Black: referee's comments green: authors' answers

Referee #1

General Comments: The paper presents a comparison of N₂O and CH₄ total and partial columns retrieved from low and high resolution FTIR spectra over the course of 8 months. The work is well motivated, technically sound, well written and easy to follow. It is interesting and within the scope of AMT.

Figure A1. The correlation plots of the 125HR and Vertex 70 retrieved N2O (top) and CH4 (bottom) columns for their coincident daily means (left) and hourly means (right). The Vertex 70 retrievals use the V2 retrieval micro-windows.

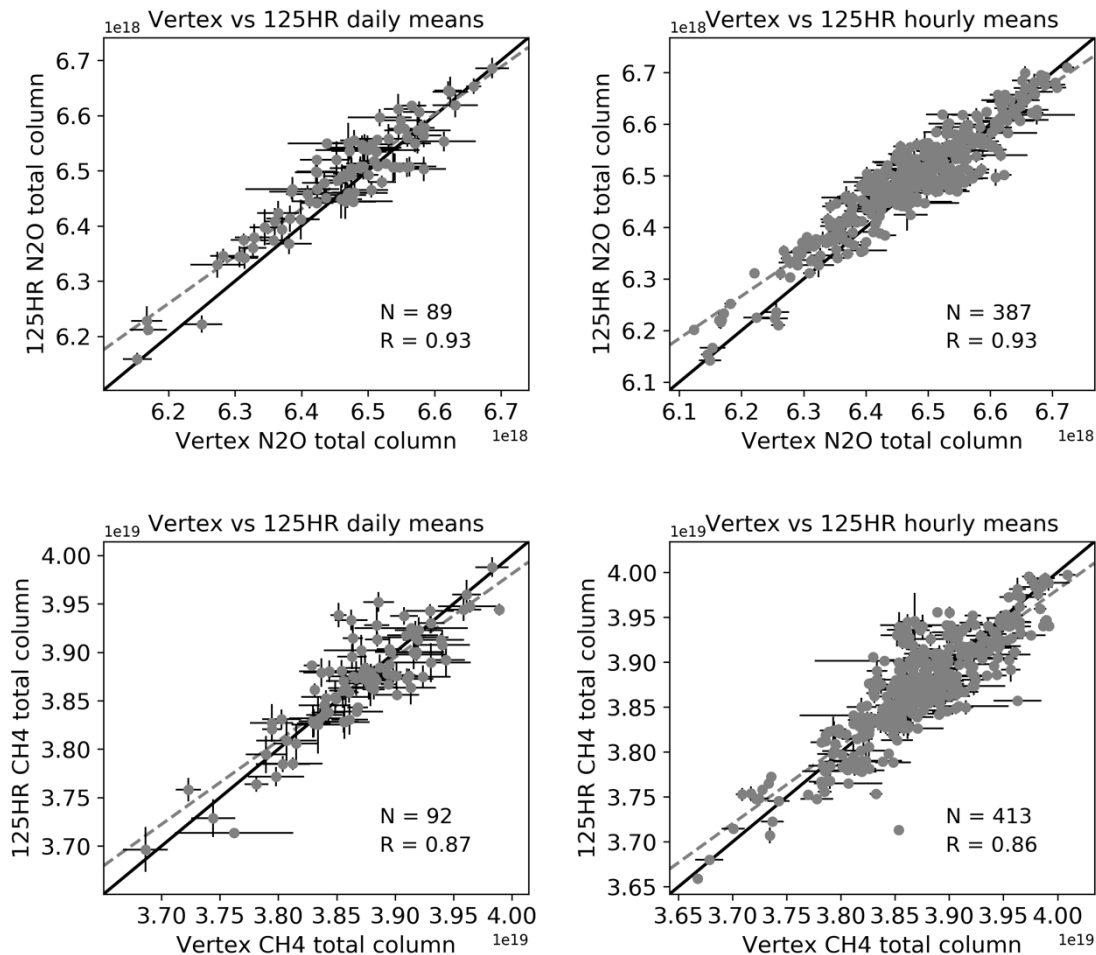
P13 F7 (left) and also P16 F10 (left): why the switch from hourly mean relative differences to daily mean total column correlations? What is N and R for hourly mean total column correlation plots (without error bars necessary)?

The correlations using hourly means or daily means are similar (Figure A1). The hourly means are plotted here to have a better view of the measurement month.

Figure A2. The correlation plots between the 125HR N2O and CH4 retrievals for total column (left), for partial column in 0-6 km (middle), and for partial column in 6-30 km (right).

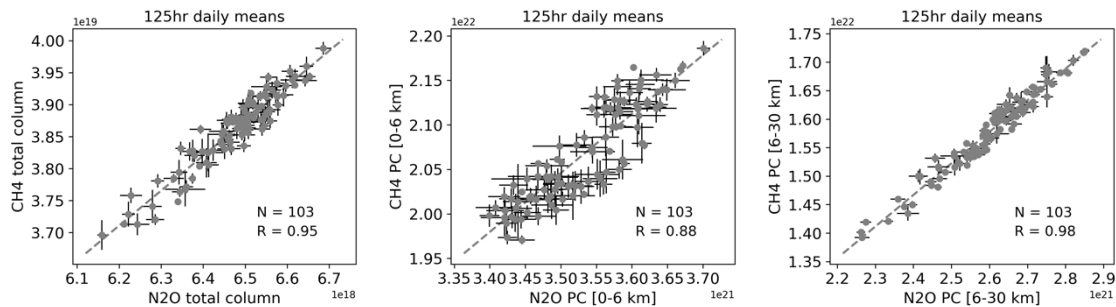
P19L2 "total columns" --> since we know that stratospheric CH4 and N2O are well correlated, why not look at partial columns in F12 instead of total columns? I realize now that CH4 DOFs do not permit it for V70-v2, but would the correlation be even more compact for 125HR partial columns?

Thanks for the comments. Indeed, the DOFs of V70-v2 (~1.3) only allows us to use the total column. We plot the partial columns of CH4 and N2O from the 125HR here (6-30 km). The correlation of the partial column is better, but it is not comparable with the Vertex retrievals (so we not show them in the manuscript).
